FINDLAY CITY PLANNING COMMISSION

STAFF REPORT December 10, 2015

1. PRELIMINARY PLAT APPLICATION #PP-01-2015 for Hickory Lake 1st-3rd Additions

3. SITE PLAN APPLICATION #SP-28-2015 filed by Country Club Acres, Inc., 655 Fox Run Rd., Findlay for Senior Housing complex to be located at 11815 TR 145, Findlay

PP-01-2015

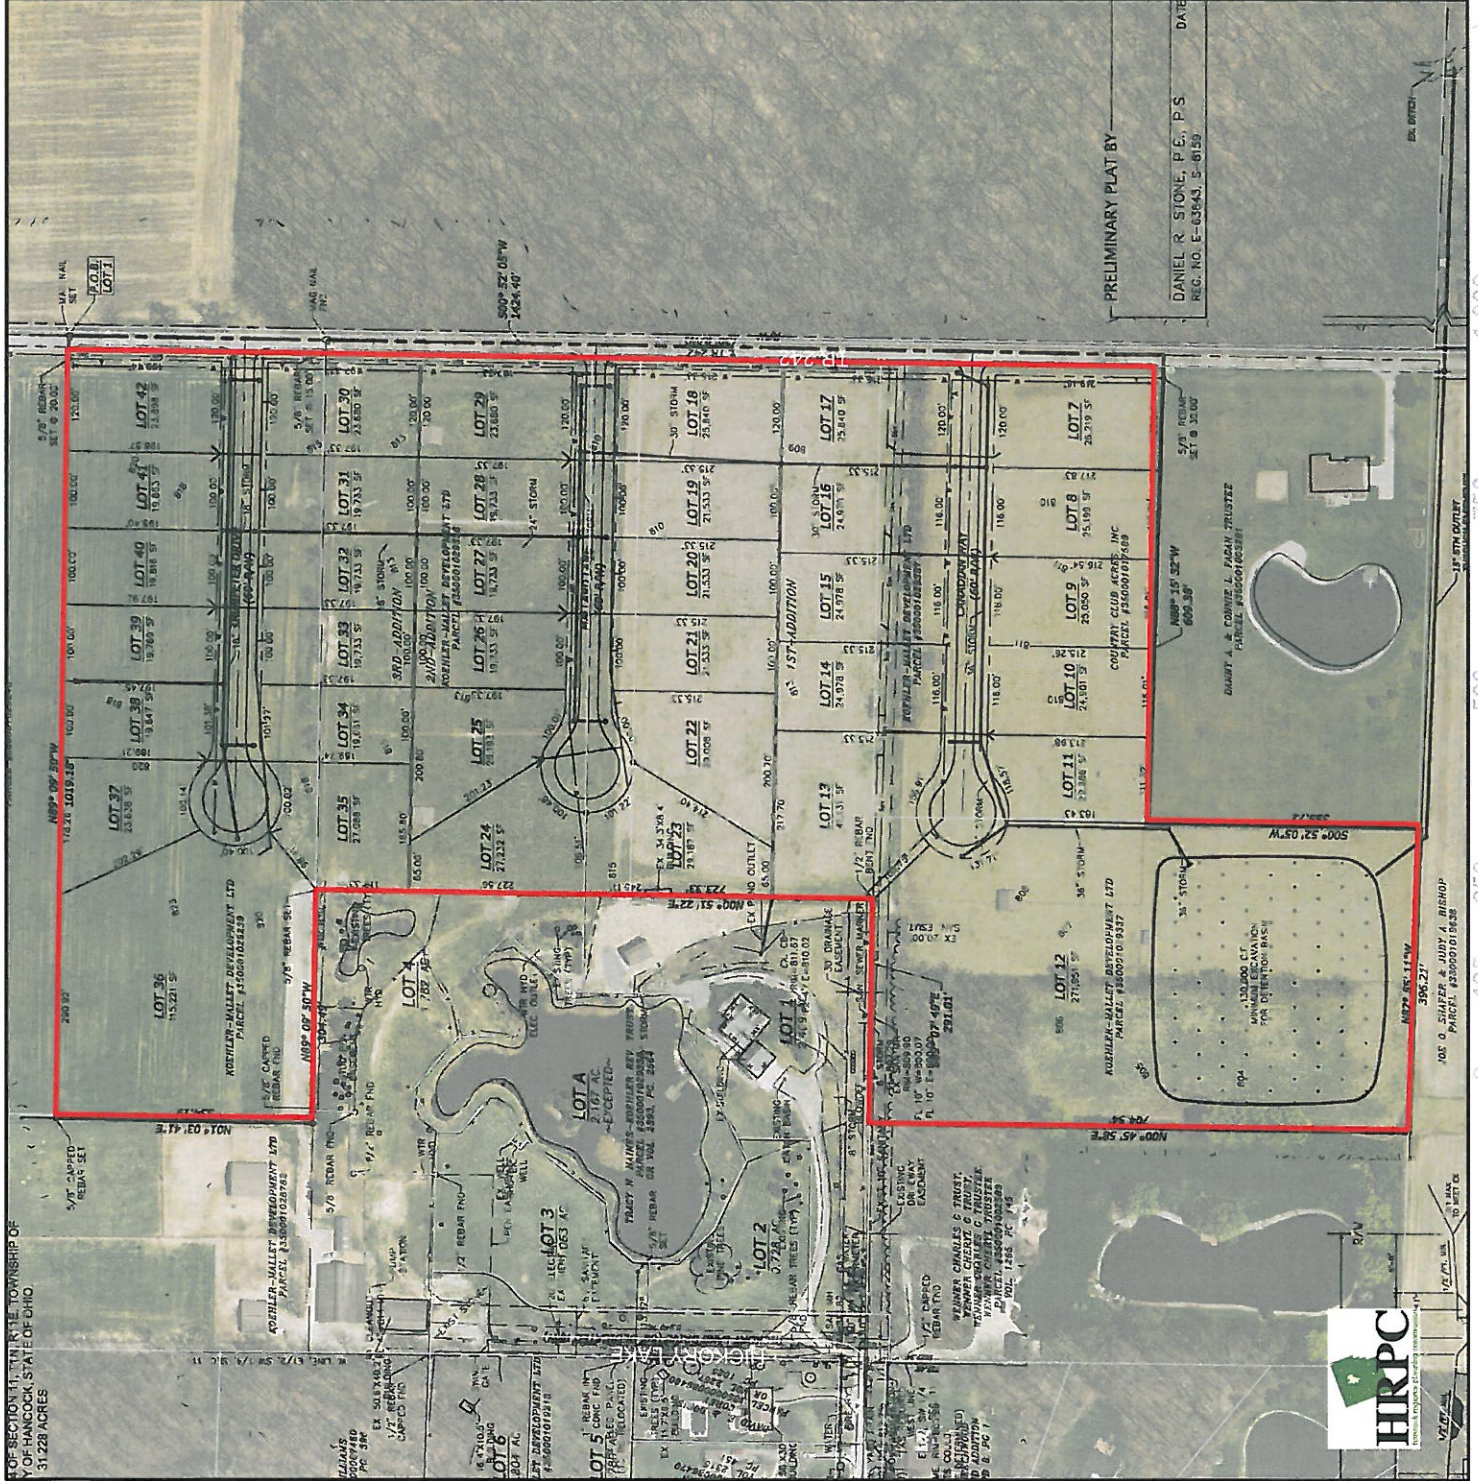
Something that was missed back in 2014 and even last month at the HRPC review of the plat is that TR 242 is designated as a Secondary Thoroughfare on the County's Thoroughfare plan. Secondary thoroughfares require 80' of right-of-way. This means that the developer will need to dedicate 25' along the length of his subdivision for additional right-of-way on the west side of TR 242. That will mean an extra 10' has to be added to the right-of-way line as shown on the plat. The lots affected will still exceed the 100' of frontage that is required in the Marion Township Zoning Resolution.

Provide a looped water system with hydrants properly spaced.

- Add 10' to the right-of-way dedication along TR 242 (HRPC)
- Provide a looped water system with hydrants properly spaced.

Final Subdivision Plat of
HICKORY LAKE
1ST ADDITION
 BEING A PART OF THE SW 1/4 OF SECTION 11, T1N, R11E,
 MARION TOWNSHIP, COUNTY OF HANCOCK, STATE OF OHIO.
 13.620 ACRES

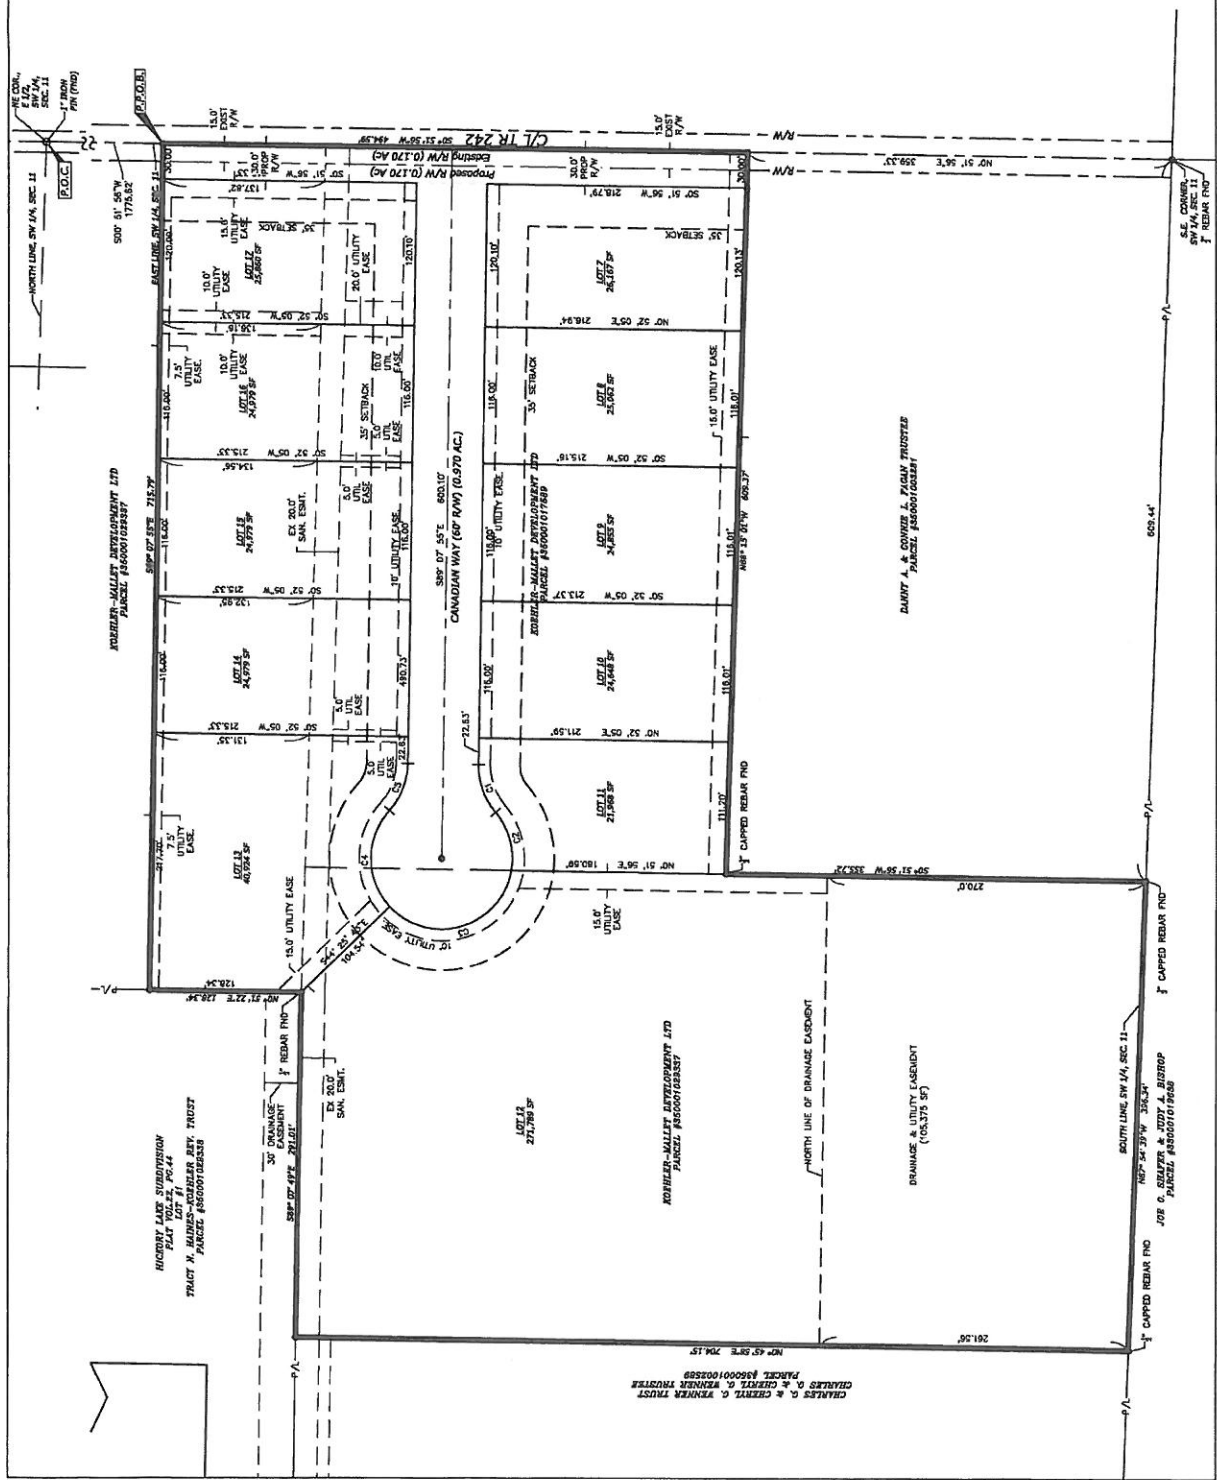
As stated in the preliminary review, the right-of-way dedication along TR 242 needs to be increased by 10' to bring the west side of the centerline to 40'.

It appears that the street is to be public. We have heard back and forth between private and public in previous conversations. The status of the street needs to be verified now so the construction standards approved will be correct.

For lots 13 to 17, it might be less confusing if the setback line was moved to coincide with the sanitary sewer easement.

Provide a looped water system with hydrants properly spaced.

- Dedication of an additional 10' of right-of-way along TR 242 (HRPC)
- Verification of whether the street is public or private. (HRPC)
- Provide a looped water system with hydrants properly spaced. (FIRE)
